TOWN OF DILLON
Planning and Zoning Commission
Regular Meeting

STAFF SUMMARY

AGENDA ITEM NUMBER: 3.a.

A RESOLUTION RECOMMENDING APPROVAL OF A LEVEL IV DEVELOPMENT APPLICATION FOR A PUD DEVELOPMENT PLAN FOR 780 LITTLE BEAVER TRAIL.

Figure 6. Measured Yards (Property Line Setbacks) (Source: N|V|5 ALATA 04/18/2023)

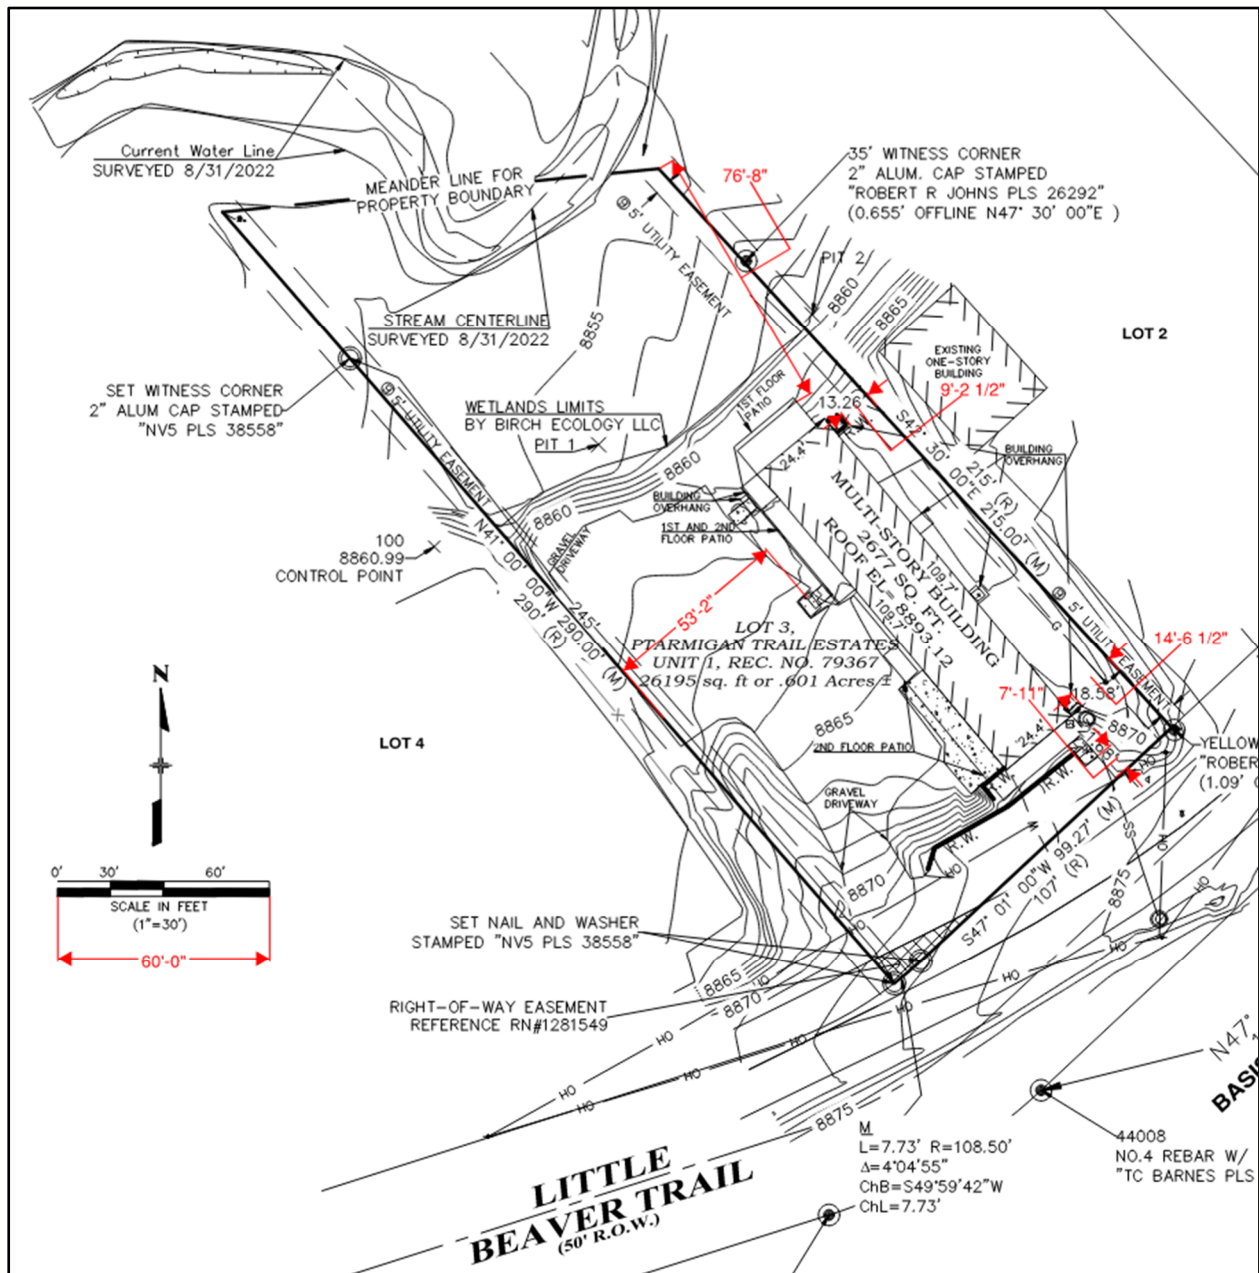
Yards: The site is already developed, and no new exterior building construction or additions are planned with this application. The yards (setbacks) were evaluated during the review of the application to document the existing conditions by reviewing the ALTA survey. The setbacks are found to be nonconforming existing conditions in some cases, as presented in **Figure 5**.

Should the property be completely redeveloped, the Town expects the required yards / setbacks of the underlying Mixed Use (MU) zone district to be met unless otherwise approved through consideration of a new PUD. Yards are intended to buffer properties from adjacent properties and rights-of-way, and thus are deemed an important site feature for all but Core Area (CA) zone developments. No maintenance or replacement due to a catastrophic loss shall increase the nonconforming condition (DMC § 16-4-80 (4)). The measured setbacks from the structure to the property lines are shown in **Figure 6**.

Figure 7. High and Low Building Foundation Elevations (Source: N|V|S ALATA 04/18/2023)

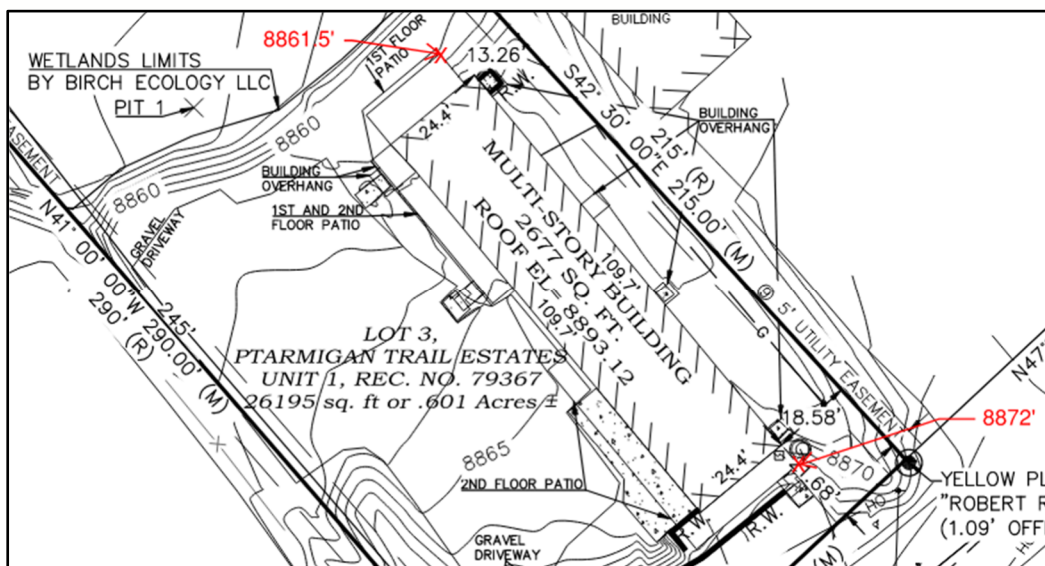
Building Height: The site is already developed, and no new exterior building construction or additions are planned with this application, so there will be no change in the building height. The building height was evaluated similarly to the reason for the setback evaluation. In the case of building height, the existing structure conforms with the maximum building height in the Mixed Use (MU) zone district of thirty-five (35) feet.

The highpoint and low point elevations of the foundations were determined from the ALTA survey and the building height was then calculated and shown to be below the thirty-five (35) foot maximum height as shown in **Figures 7 & 8**.

Figure 9. Mapped Wetland Delineation (Source: Brich Ecology LLC)

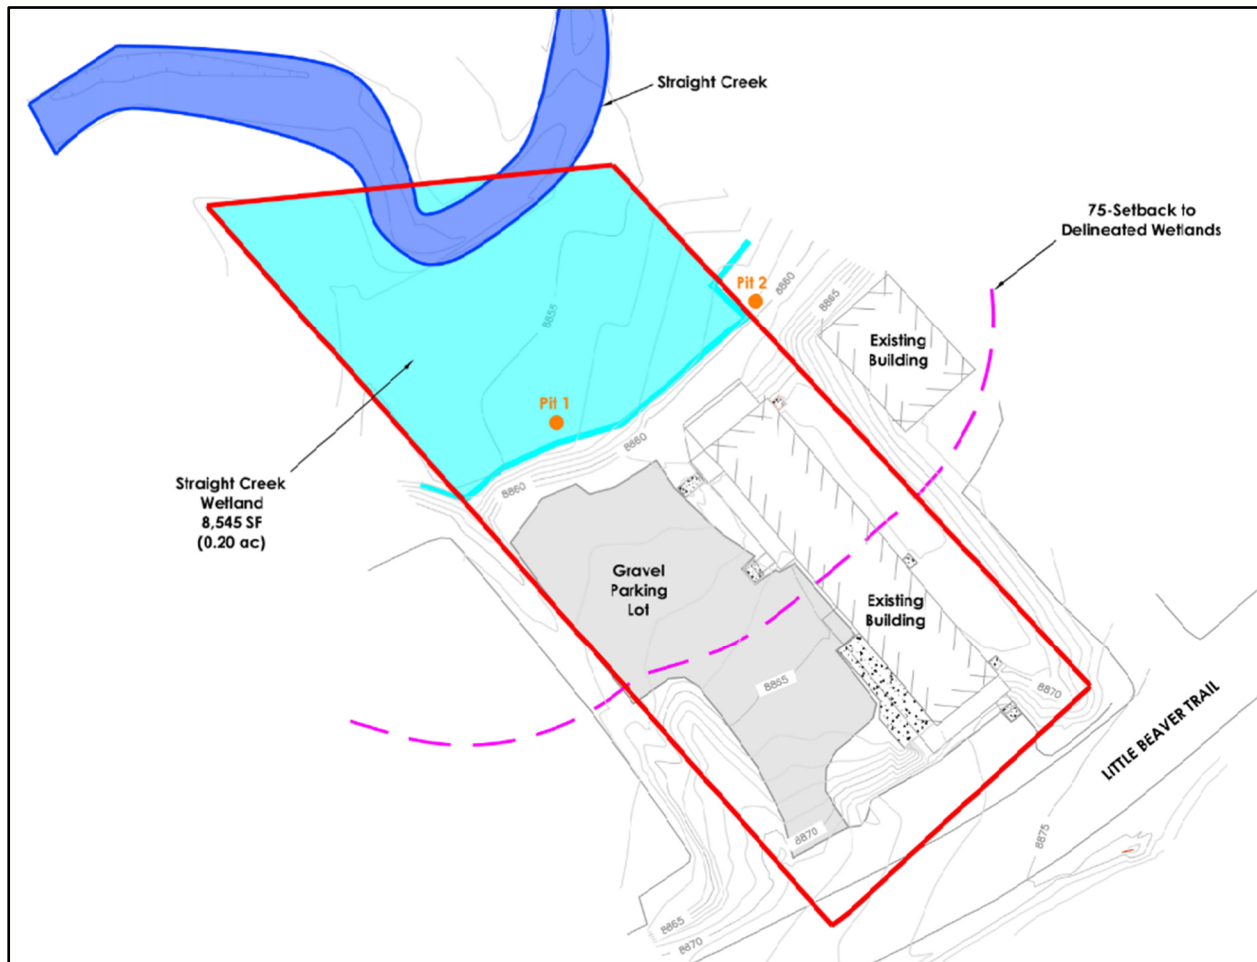
Wetlands: The Code sets forth regulations to protect sensitive wetland areas, to limit human activity in wetland areas, to protect wildlife habitat, and to promote the uses of Best Management Practices to protect wetland resources. A wetland delineation report was prepared for the site by Birch Ecology in March 2023 based upon a July 2022 wetland delineation (see **Exhibit ‘D’**). They observed the limits of Straight Creek and the wetland vegetation dominated by willows and introduce grasses and weeds. They find that the grade break on the property well defines the wetland boundary, and thus mapped the wetland area as shown in **Figure 9**. The grade break relates to a fill embankment from a previous permit through the Army Corps of Engineers for various properties along Little Beaver Trail and Straight Creek.

The Straight Creek riparian wetland is defined as a principal water body wetland, as such a seventy-five (75) foot wetland buffer area is required. The Code limits certain activity within an identified wetland buffer area, and further identifies certain activity that is permitted. The permitted uses are found in Section 5.6 of the Wetland Regulations provided in **Exhibit 'D'** and include the activity proposed for the already developed site: deconstruction of existing concrete improvements and gravel driveway and parking area; construction of retaining walls; placement of fill; construction of storm drainage and detention facilities; construction of concrete improvements; and placement of aggregate base course and asphalt pavement all associated with the safety and site improvements proposed to support the interior building upgrades.
